Geotechnical Engineering Report

Proposed Acorn Valley Development

83 Christie Drive, Dorchester, Ontario

Revised Report

Project : Proposed Residential Subdivision

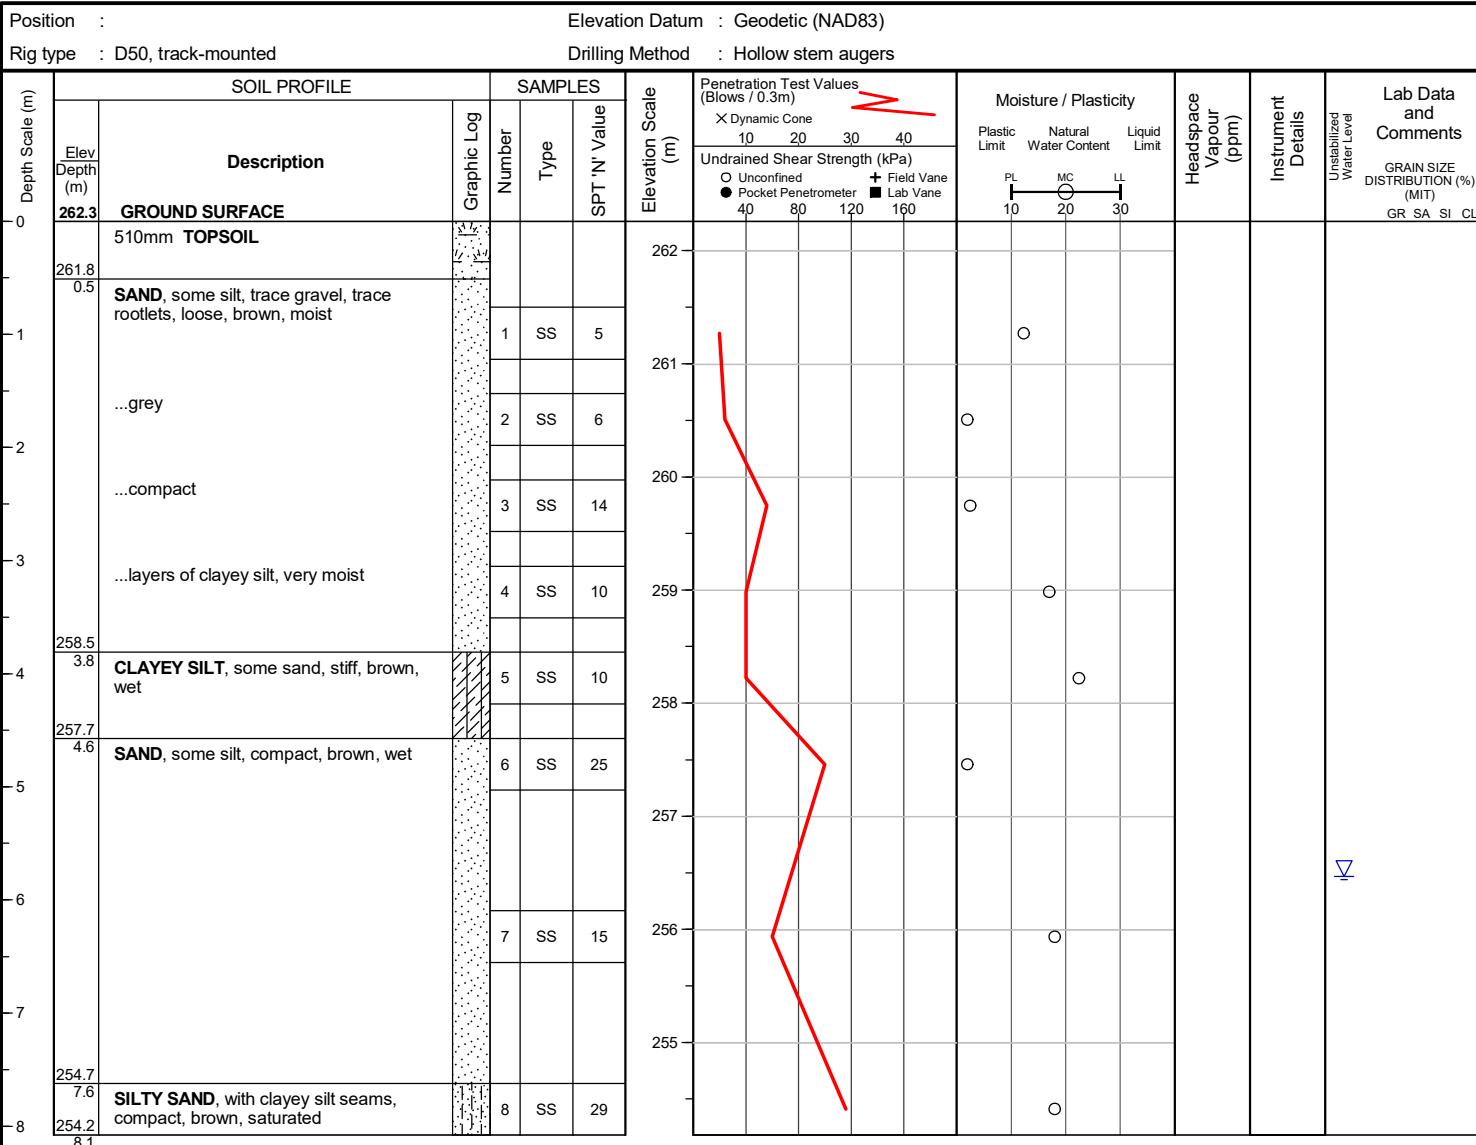
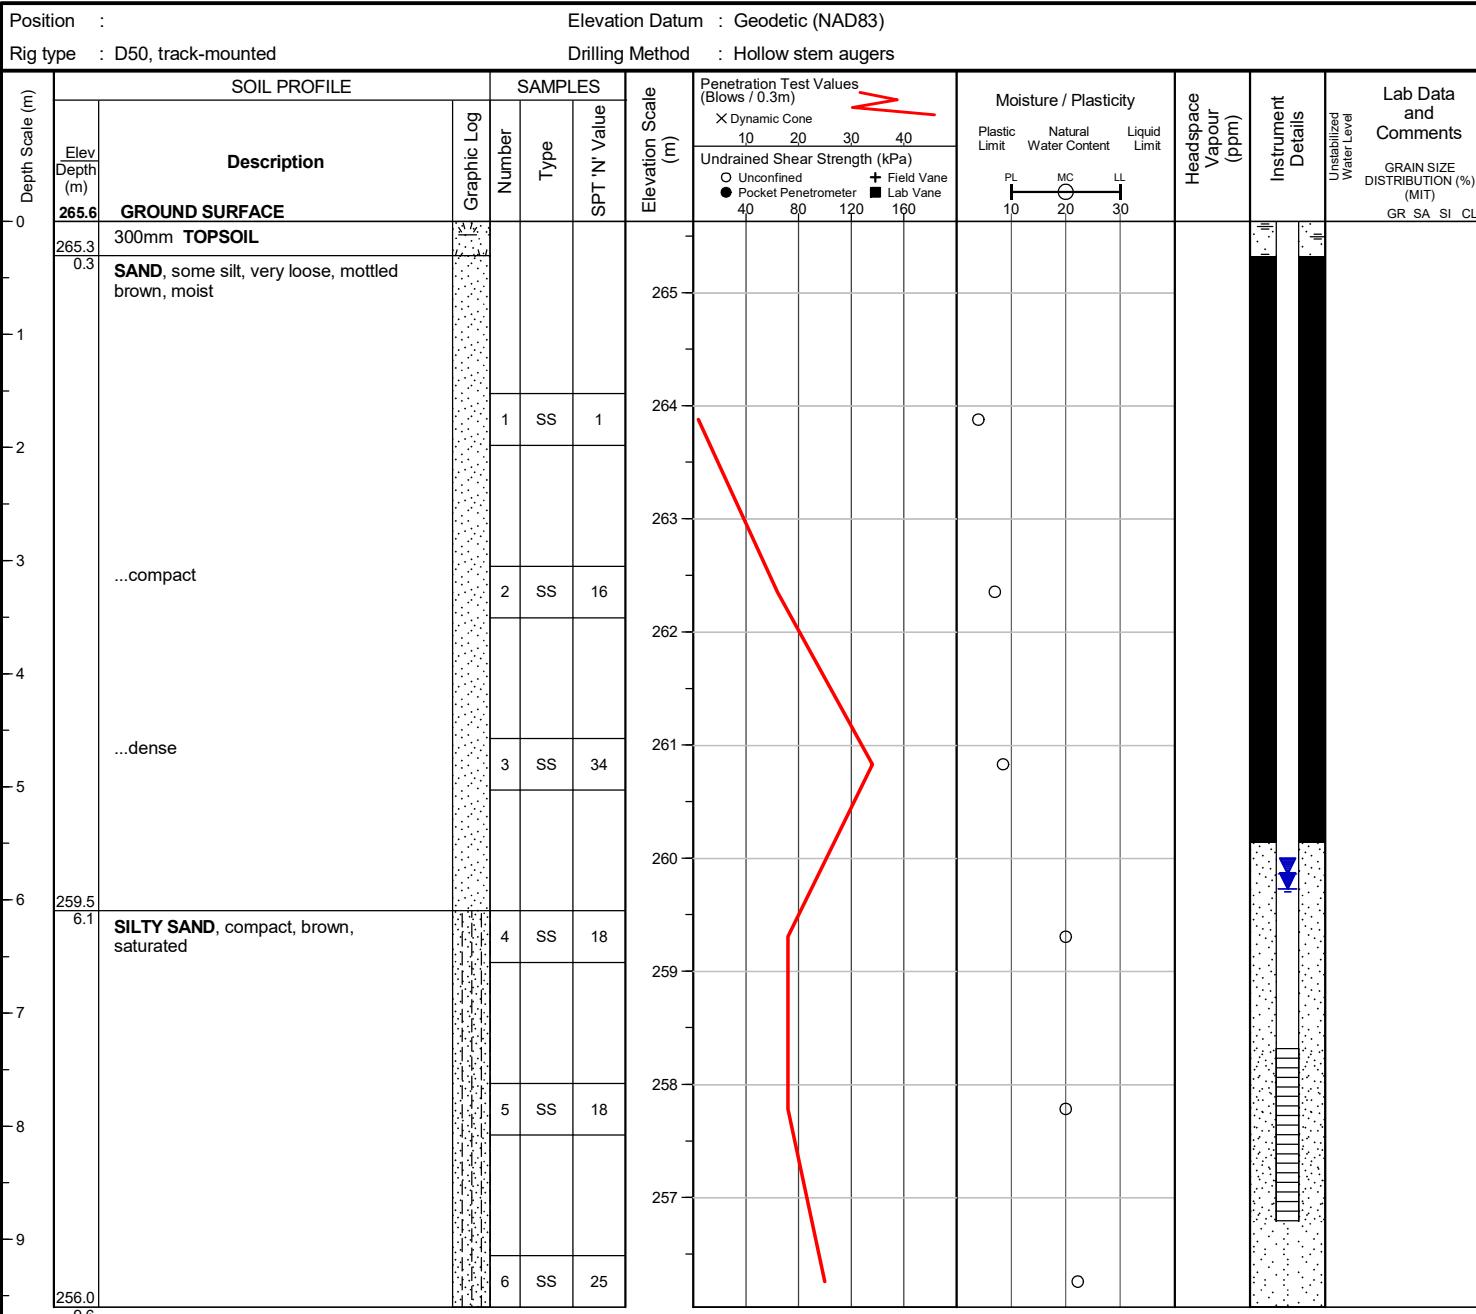
ITEM No.	Section	CLIENT COMMENTS	Englobe Response	CLIENT DECISION/CONCLUSION
G5		The log for borehole 10 in Appendix C shows the groundwater level at approximately 2.25 m below ground but is stated as 3.23m in the body of the report. Please confirm.	Updated borehole logs.	
G6		Please confirm that the 8 cross-sections shown are considered critical sections of the corresponding slopes.	As summarized in Table 5, the slope at Section 5-5' was considered the critical slope section and was therefore selected for analyses.	
G7		Please also include the 6m erosion access allowance on the detailed cross-sections.	Updated as requested	
G8	5.5	states that based on the findings of the analysis the proposed trail (in the vicinity of cross-section A-A') can be safely constructed without adversely affecting the long-term stability of the valley slope. No risk to life or property damage is anticipated. Please include decision on watermain as well as the trail.	Revised accordingly. Added recommendations for slope restoration.
